Brief Design and Access Statement

Demolition of existing attached garage, proposed single storey rear extension, double storey side extension, part double storey rear extension, new second floor and roof extension with rear facing dormer window and rooflights

**43 Highfield Drive
Ickenham
UB10 8AW**

13 October 2022

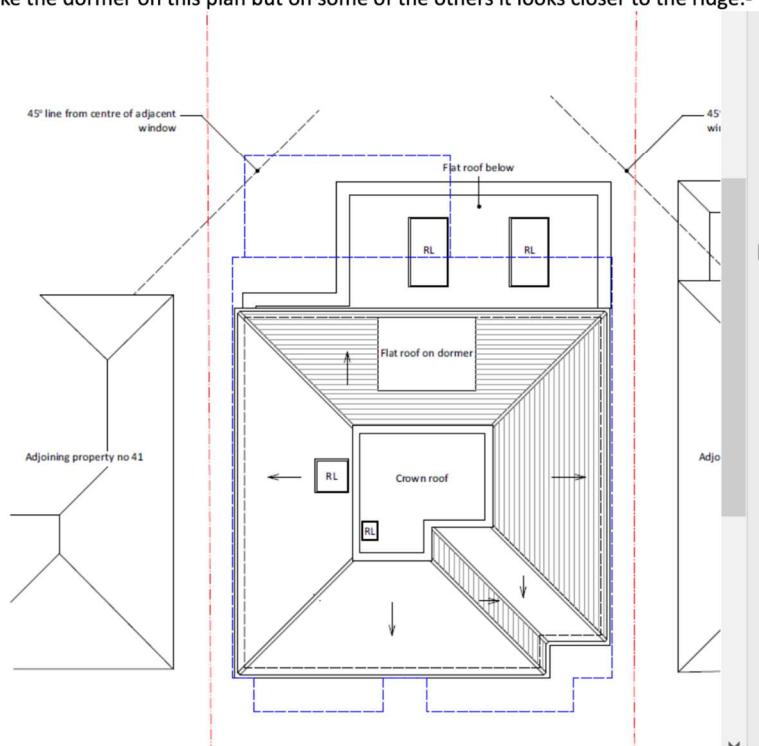
I like the comparative analysis with the earlier refusal and is a very helpful tool.

I would be surprised if we could object to the scheme on adverse neighbour amenity impacts and the revision removes the front elevation.

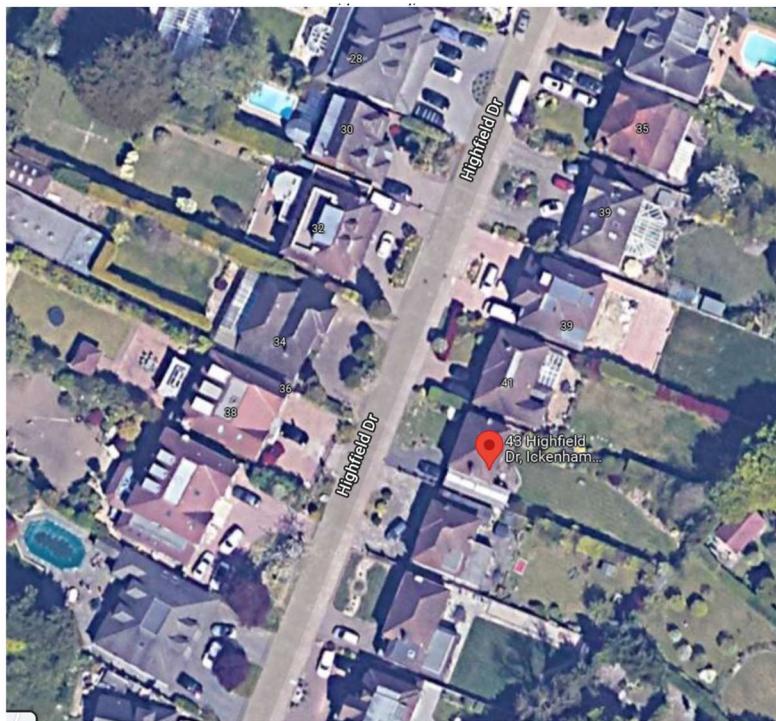
I like the dormer on this plan but on some of the others it looks closer to the ridge:-

- We enclose amended drawings B01B, B02B, B05A, B06A and B07A for your comment
- We have checked the dormer window and re-adjusted so that it is more than 300mm from the ridge as per HDAS
- We have shown PV panels on the southern roof slope (adjacent to no.45)
- A horizontal loop system for a ground source heat pump could work due to the length of the garden, also shown

Yes, that incorporates my comments.
